Re: Northfield Mountain Pumped Storage Project, FERC No. 2485-063
Turners Falls Project, FERC No. 1889-081

Comments on the Updated Proposed Study Plan (PSP) submitted by FirstLight June 28, 2013.

Figure 30: Model illustrating idealized sequence of erosion. Different stages of erosion can be occurring adjacent to each other along a long continuously eroding bank.

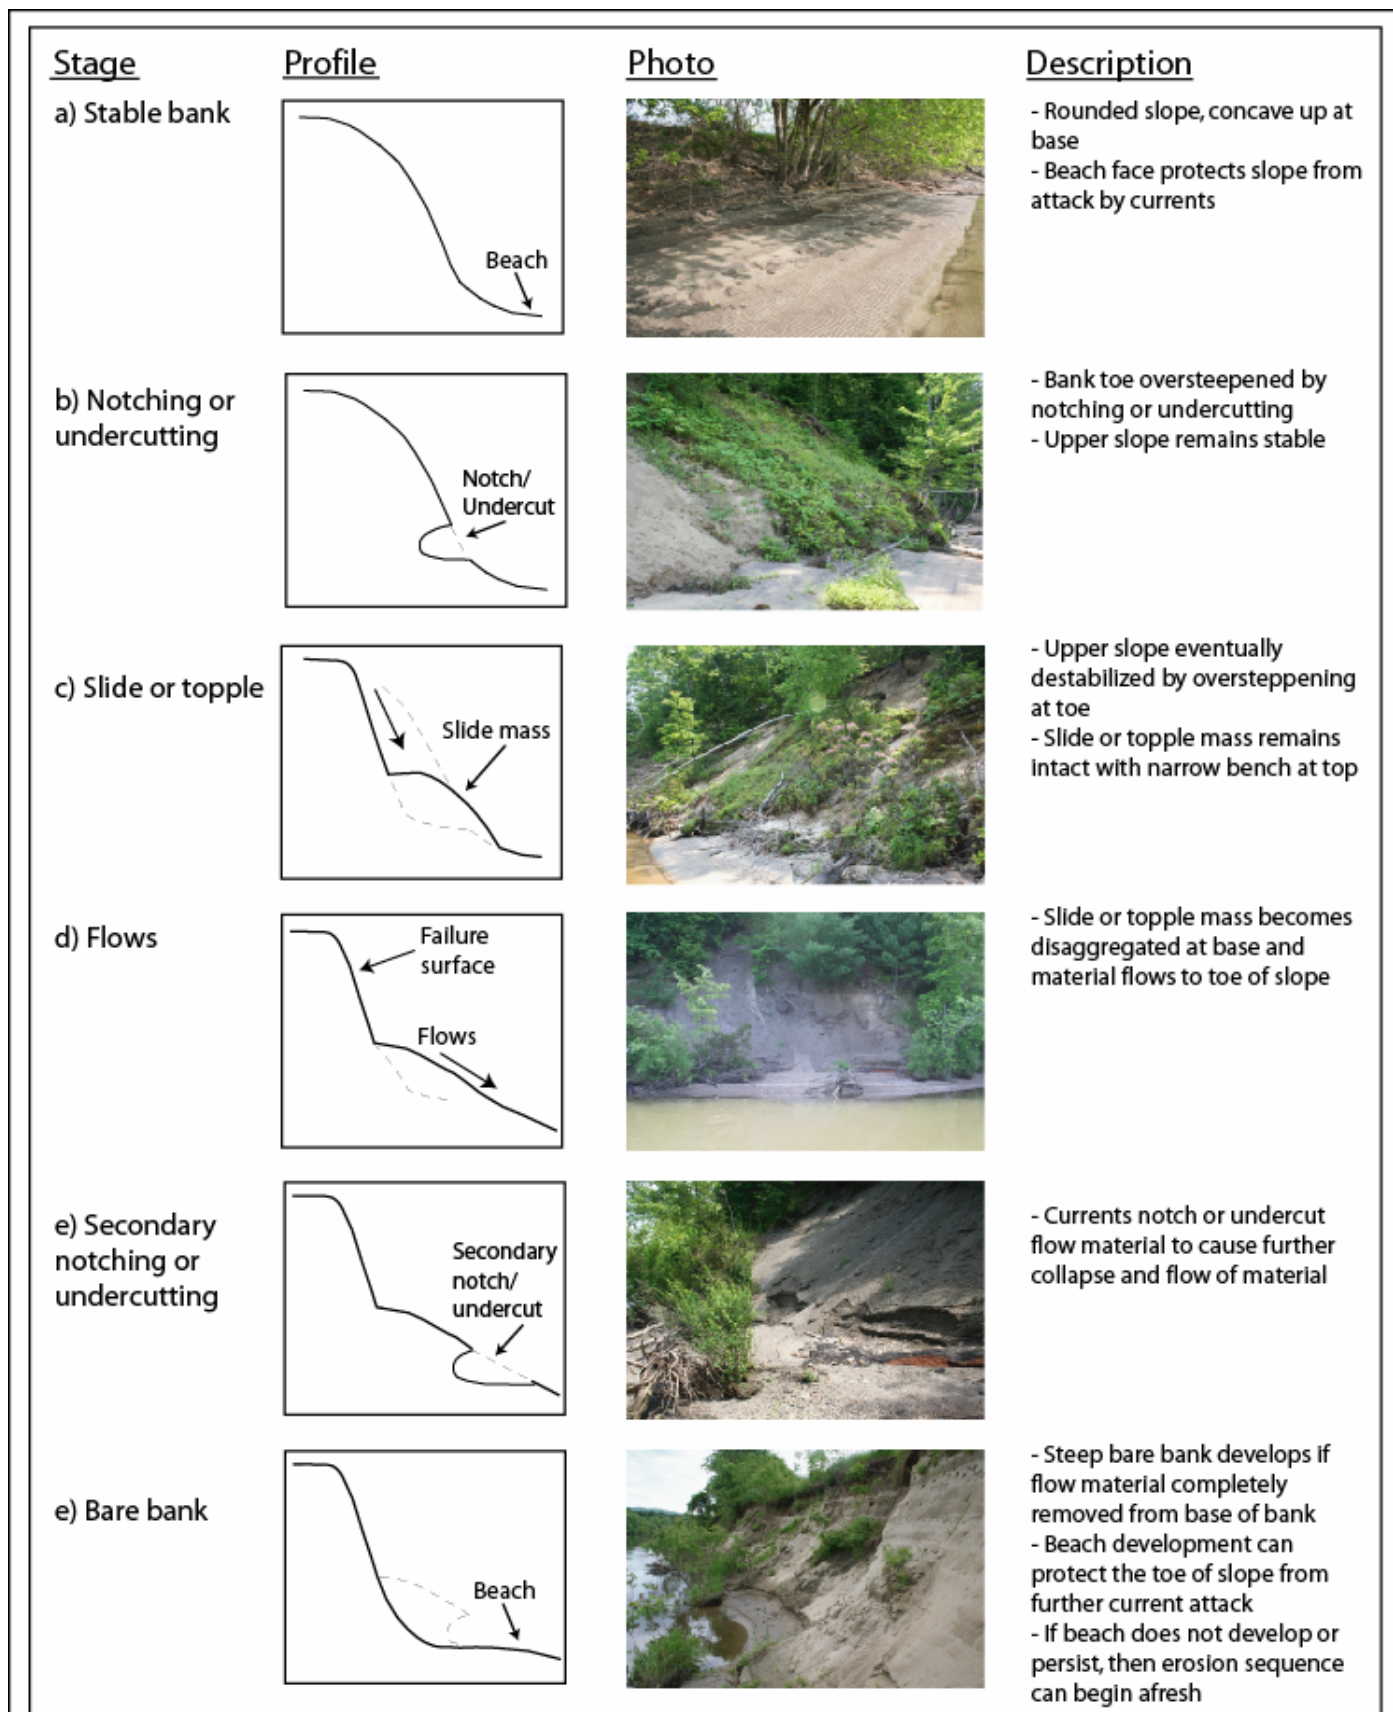
Another fatal flaw in these tables is the use of the category “mass wasting” to characterize the extent of erosion. First, mass wasting describes the movement of material downslope under the influence of gravity. The term lumps three types of erosion - flow, slide and fall - and the term doesn’t describe what erosional stage is responsible for the mass movement of the bank material. Mass wasting is a generic term to describe a typically catastrophic event like a landslide or mudslide. It is a term that should be more accurately used (if at all) as a grouping of erosion types. To characterize the spatial extent of erosion, we should be gathering data on the linear and vertical extent of the specific types of erosion as identified by Field (2007), which can be quantified, rather than combining types of erosion into one category and using qualitative terms like “little/none”, “some” or “extensive” to describe the erosion. These qualitative terms are not valid due to their extreme subjectivity and should not be used at all in the relicensing studies to describe the erosion in the Turners Falls Pool. According to Field (2007), four of the erosion types described by Lawson (1985) are widely observed in the Turners Falls Pool: falls, topples, slides, and flows (Field (2007) Tables 1 and 2), which are attached to this letter. Dr. Field noted that these four erosion types rarely occur in isolation, but rather work in concert to remove bank material from the upper and lower slope. According to Dr. Field, visual observations of bank conditions at various places in the Turners Falls Pool permit the development of an idealized model that describes a sequence of events occurring through time at a single point (Field, Figure 30), which is attached.

On page 3-8, it is stated that the 2008 and 2013 FRR methodologies include the six stages of erosion identified by Field (2007). We assert that this is a misrepresentation of what Dr. Field identified in his report. He provides definitions for each stage of erosion, along with a picture of a representative site in the Turners Falls Pool and a profile drawing. What is presented in the 2013 FRR methodology (Table 1 on page 3-8 of the Updated Proposed Study Plan) is not comparable to Field’s Figure 30. Further, these are stages of erosion as identified by Field (2007) not types of erosion as identified in the 2013 FRR methodology. The 2013 methodology does not identify the stages of erosion. In Appendix C of the proposed QAPP for the 2013 FRR, the types of erosion listed include: none, notching, overhanging bank, undercut toe, and slide. A representative picture is provided. No citations, descriptions, or line drawings are given for the source of these types of erosion. This list of the types of erosion includes only one of the four types of erosion listed by Field (2007) – slide. In fact, it appears that the 2013 FRR methodology has confused the type of erosion with the stage of erosion or perhaps lumped the two categories and picked only a few categories to include as representative of the conditions in the Turners Falls Pool.

Field's Figure 30 presents 6 stages of erosion as presented above. These 6 combinations of riverbanks provide useful information on possible combinations of riverbank features and characteristics. The matrix of riverbank features and characteristics utilized in the 2008 FRR and proposed for the 2013 FRR provide a comprehensive set of key features and characteristics, including those outlined by Field, 2007. The use of the matrix allows for a detailed and comprehensive approach in classifying riverbanks and allows development of a detailed and comprehensive understanding of riverbanks. Each of the stages described in Field's Figure 30 is included in the matrix as shown in Table 1. Inclusion of the six descriptions of riverbanks developed by Field and the numerous other possible sets of riverbank features and characteristics in the matrix provides a comprehensive set of riverbank features and characteristics that both describe the riverbank conditions as observed in the field, as well as the stages of erosion as described by Field.

Little/None

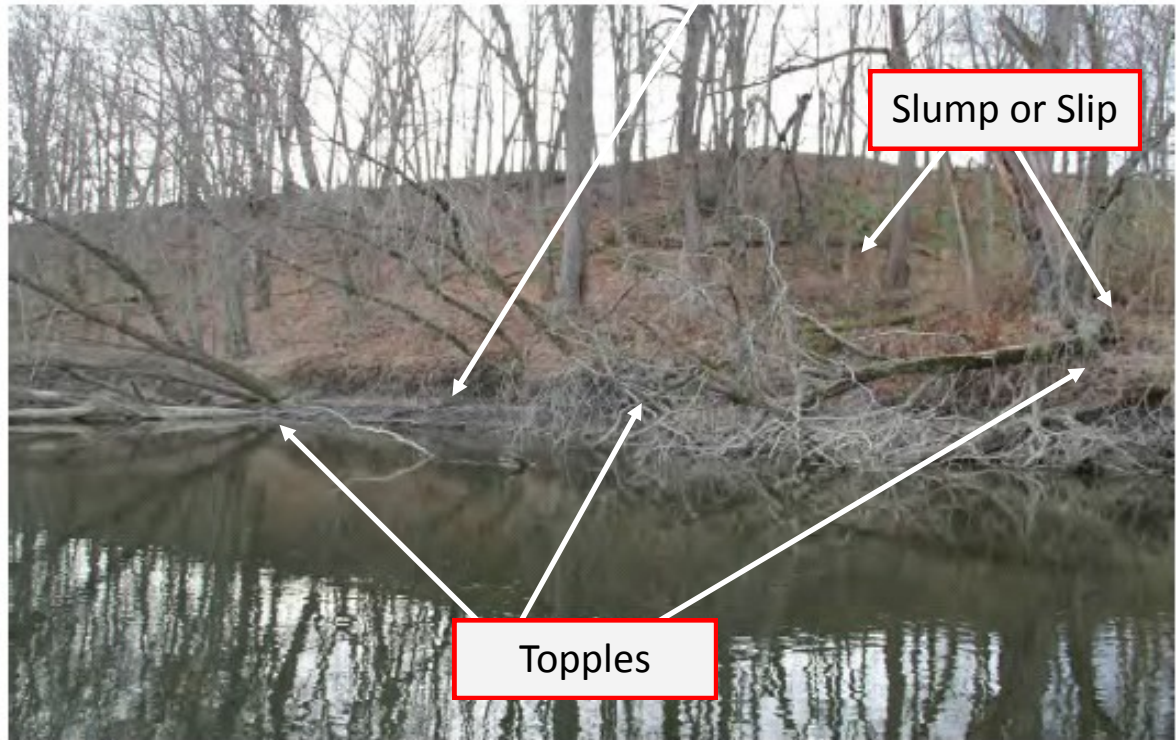
More troubling is the Mass Wasting section of Appendix C of the QAPP, which contains pictures showing “little/none”, “some” and “extensive” mass wasting. We refer back to our concerns about using the term mass wasting to describe the extent of erosion because mass wasting is a term that refers to collectively to a group of different types of erosion. An examination of the pictures shows that a variety of different types and stages of erosion are occurring in these “representative” mass wasting pictures. This important information is lost when masked by a “little/none” category, for example. To illustrate this point, looking at the attached “little/none” mass wasting pictures, there is clear evidence of different types and stages of erosion as defined by Field (2007). Clearly, the 2008 and 2013 FRR methodologies have not incorporated Field’s (2007) recommendations.

Little/None

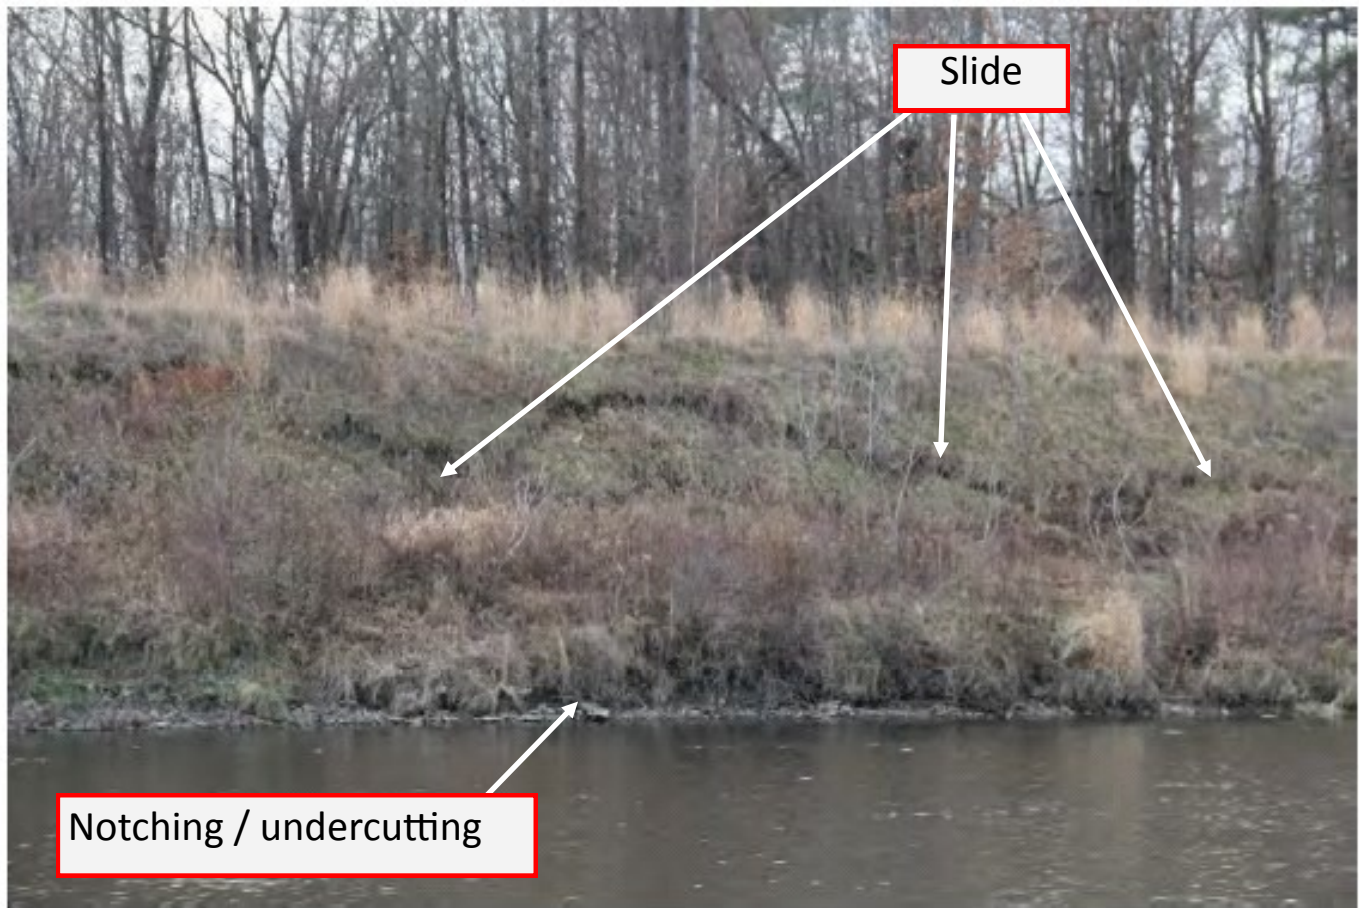
TEXT, TEXT BOXES AND ARROWS on the following pages that IDENTIFY THE TYPE AND STAGE OF EROSION after Field (2007) ADDED BY FRCOG 7-15-13.

Stage of Erosion: b and c
Erosion Type: Falls (undercuts, gullies), Topples, Slides (slump, slip)

Some

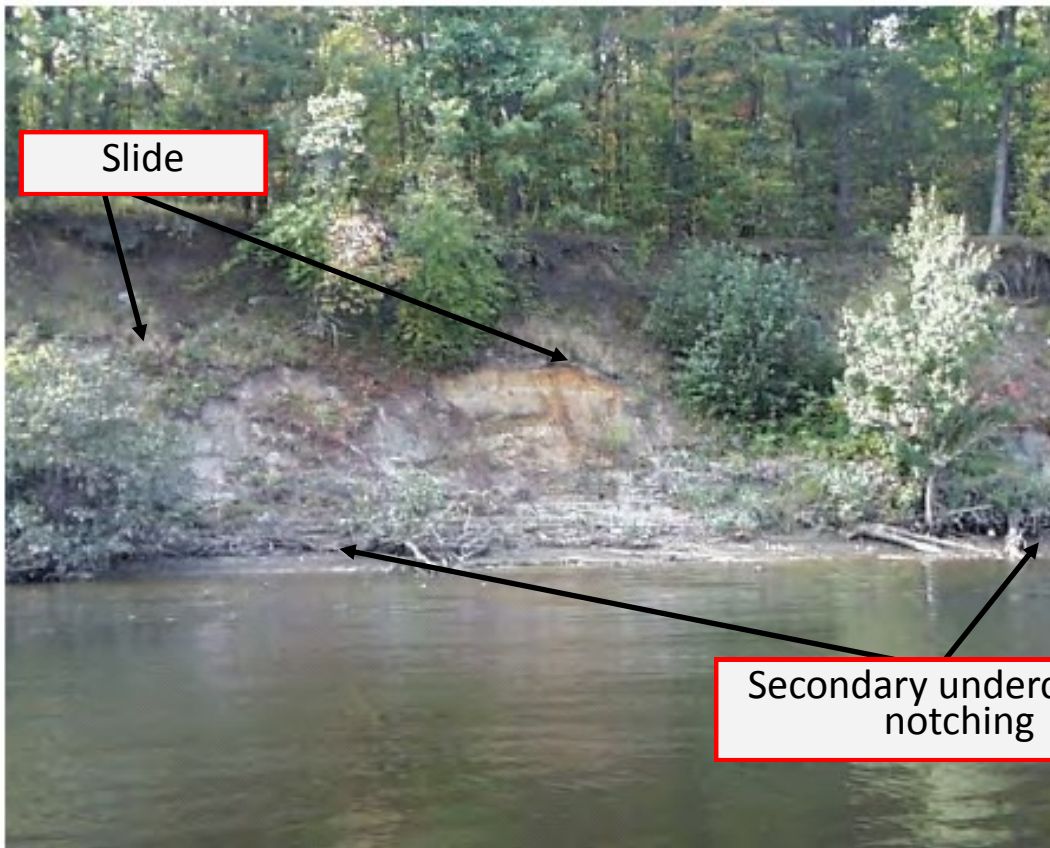
Stage of Erosion: b and c — Slide mass remains intact with narrow bench at top
Erosion Type: Slide
